Facility Name: Caesars Plaza

**RE: Response to TCEQ NOD2 E-Mail Dated 23 July 2025; MSW Tracking No. 31656747
Application for Development Permit for Proposed Enclosed Structure
Caesars Plaza, 957 W Cartwright Road, Mesquite, Dallas County, Texas 75149
MSW Permit No. 62058; RN110301553; CN606323335
SQE PN: 1239.001.001**

SQ Environmental, LLC (SQE) prepared this letter in response to the Texas Commission on Environmental Quality (TCEQ) second notice of deficiency (NOD2) e-mail dated 23 July 2025 regarding the *Application for Development Permit for Proposed Enclosed Structure* (Application) for Caesars Plaza, located at 957 West (W) Cartwright Road (Rd) in Mesquite, Texas. The initial Application was submitted to TCEQ on 31 March 2025. Responses to TCEQ's NOD1 comments were provided on 26 May and 9 June 2025. Responses to TCEQ's NOD2 comments are provided below. Attached to this letter are Revision 2 of Form-20785, and Revision 2 versions of the marked (redline) and unmarked ("clean") replacement pages of the Application.

FIGURE 1

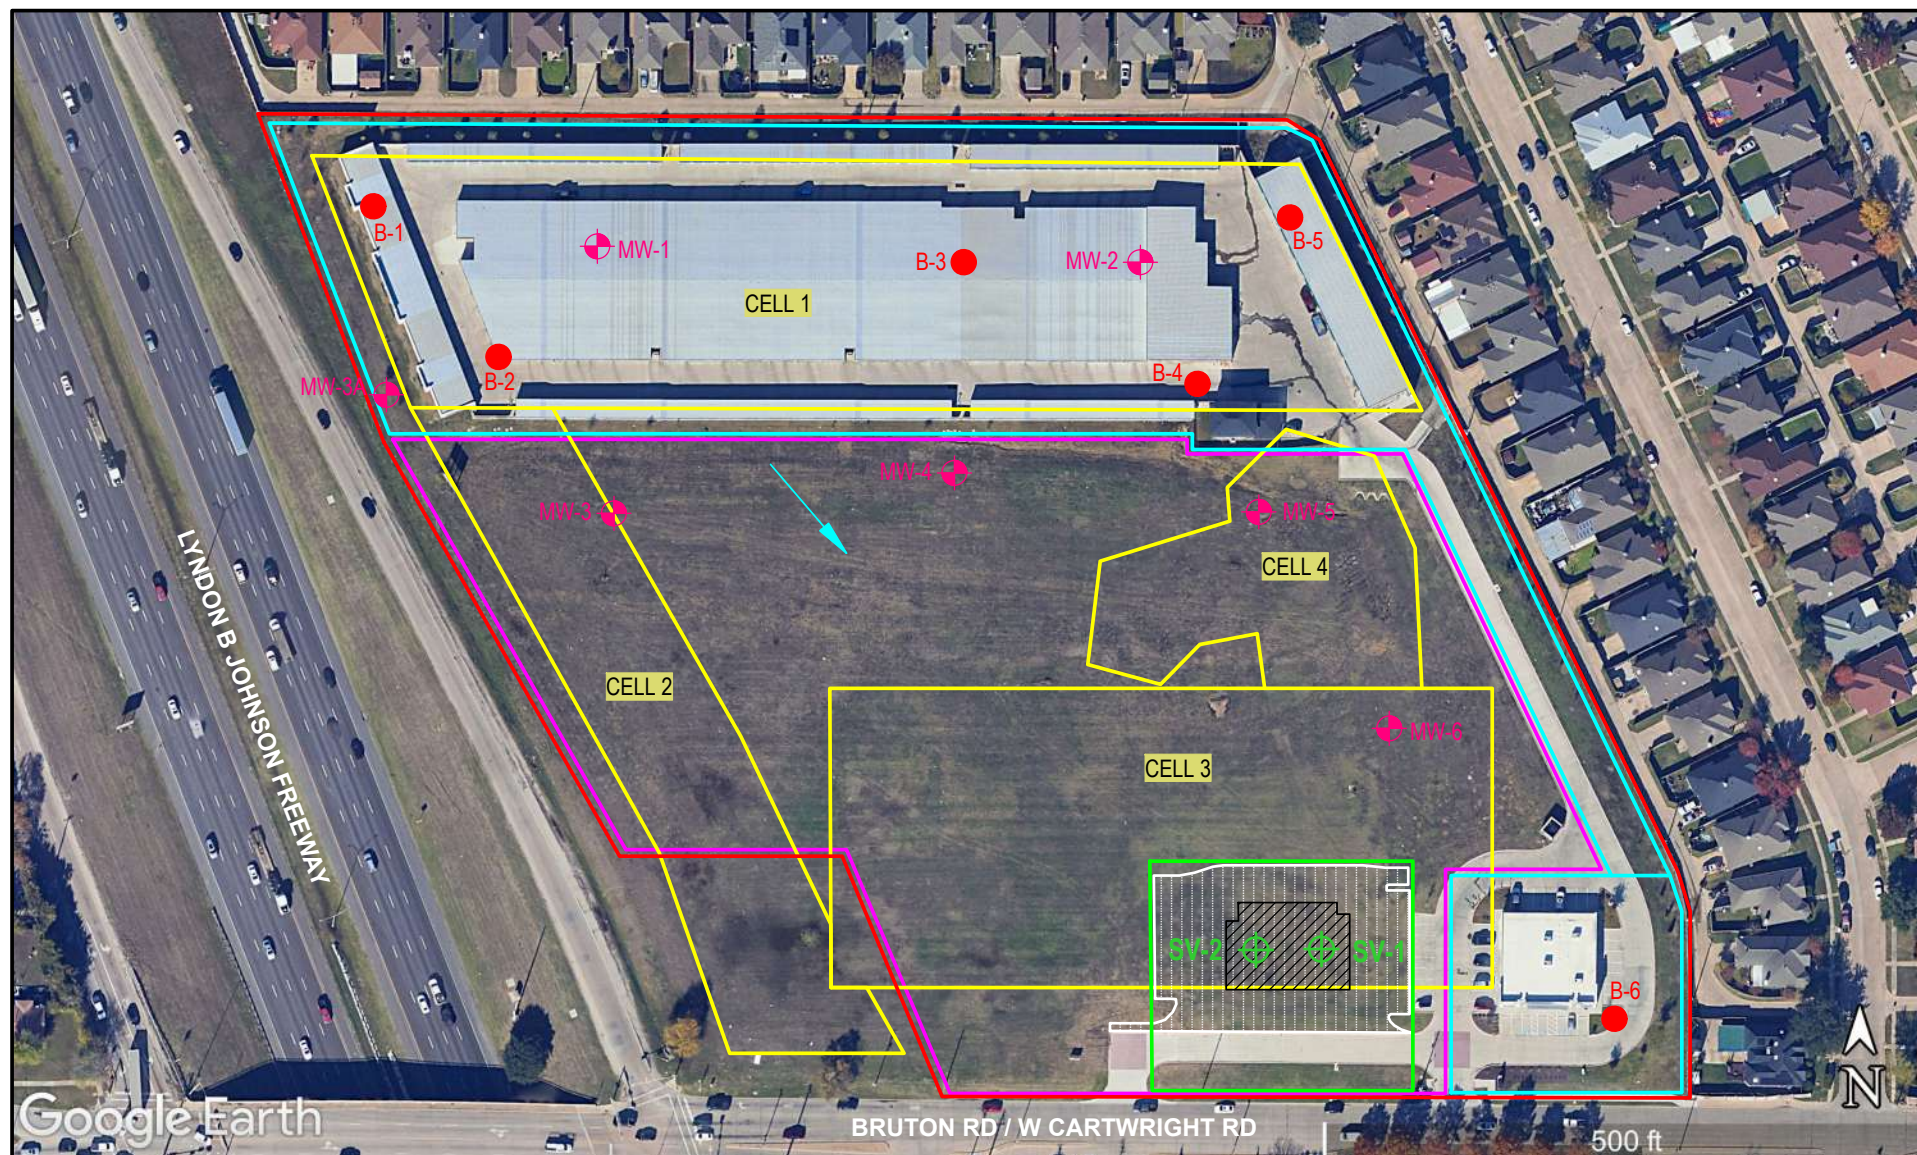
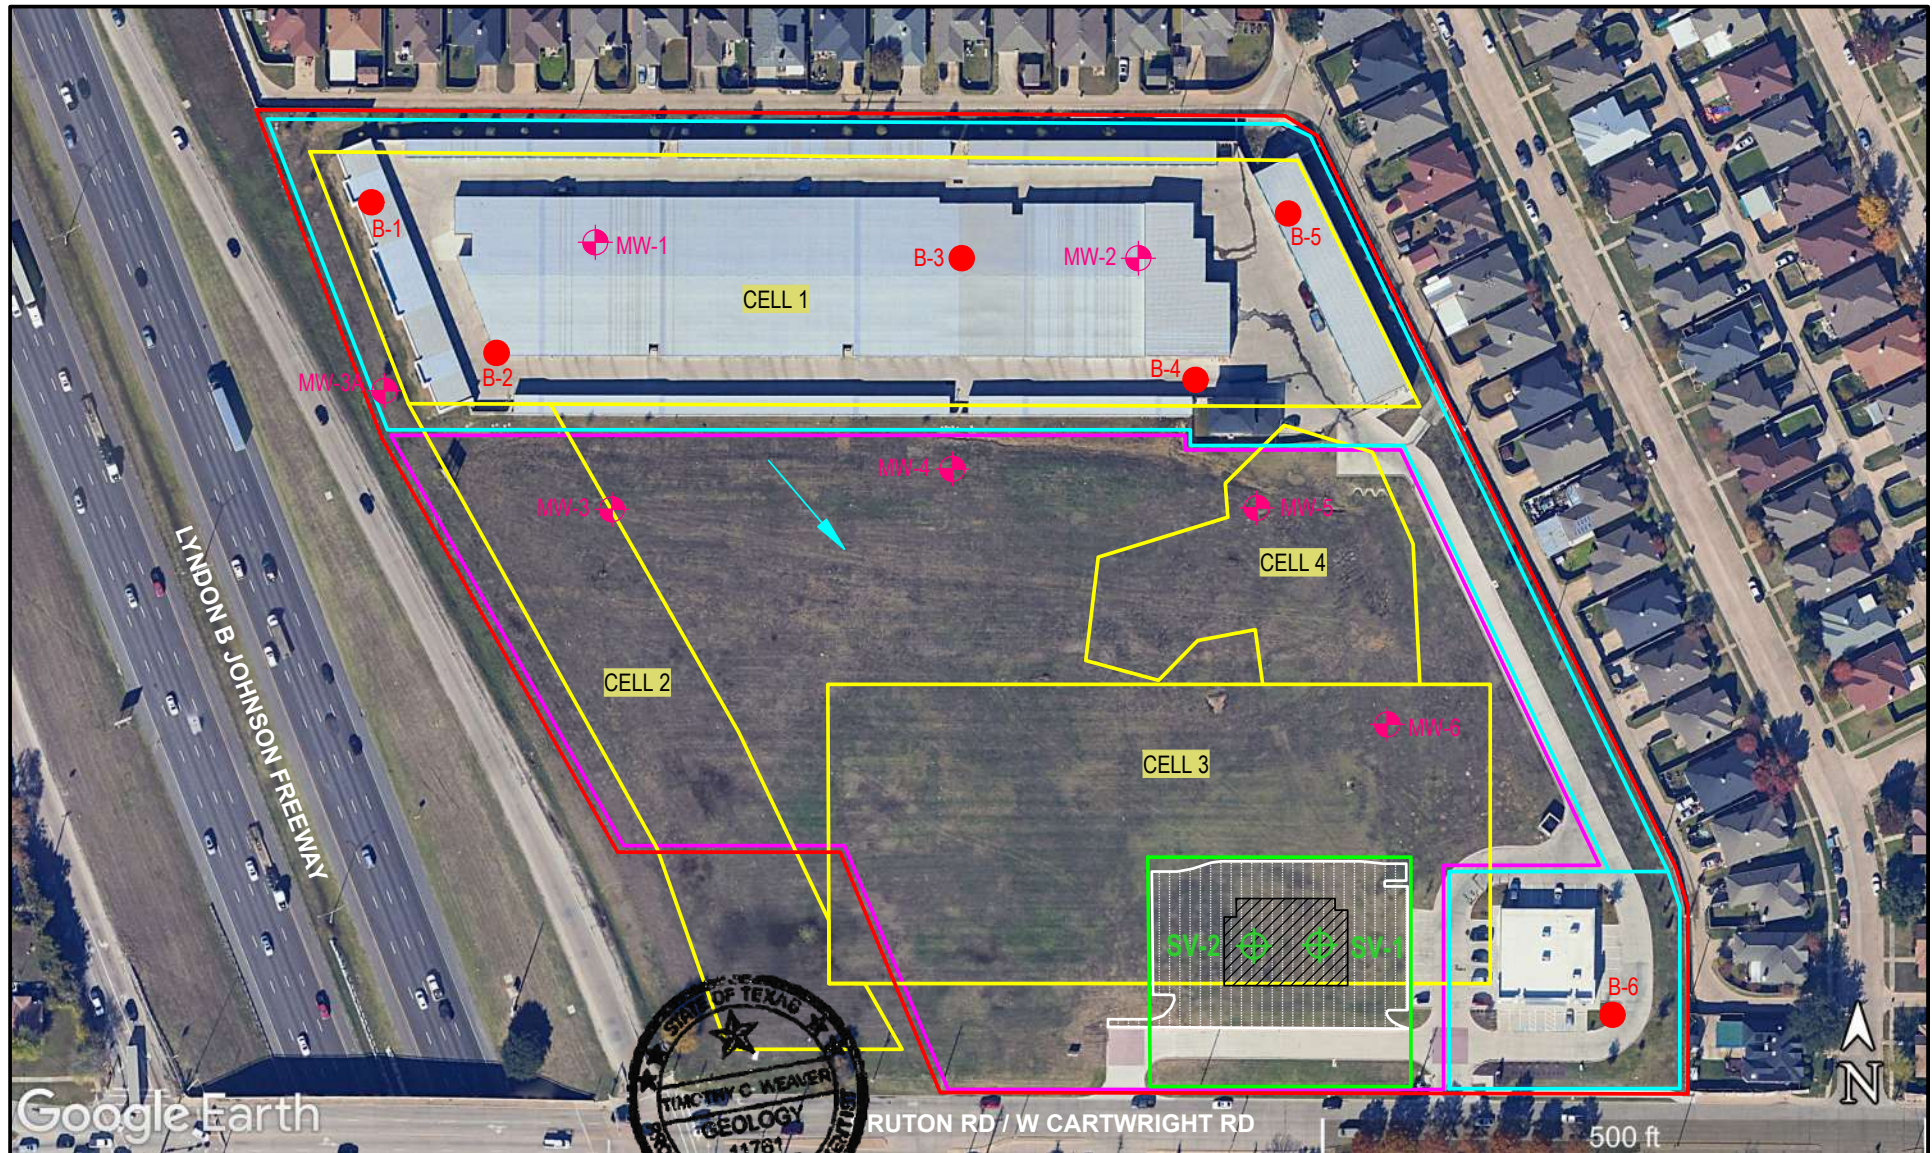
TCEQ Comment 4: *Remove references to MSW Authorization No. 67137 from drawings and maps.*

Response to Comment 4: References to MSW Authorization No. 67137 have been removed from drawings and maps. Revision 2 replacement pages of the Application figures are provided with this letter.
